Wiltshire Council Planning Consultation Response

ECOLOGY

Application No: PL/2026/01500

Site Address: Wheatlands, Rivar Road, Shalbourne, Marlborough, SN8 3RL

Fig. 1 Red line mapping as submitted for planning.

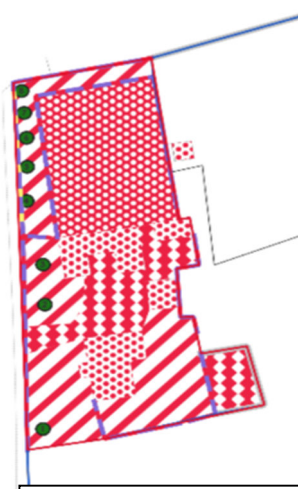
- The redline boundary used for the BNG assessment is different from the redline boundary submitted for planning. The redline application boundary and site boundary used for the BNG assessment must match.

application boundary and site boundary used for the BNG assessment must match.	
--	--	--	--	--
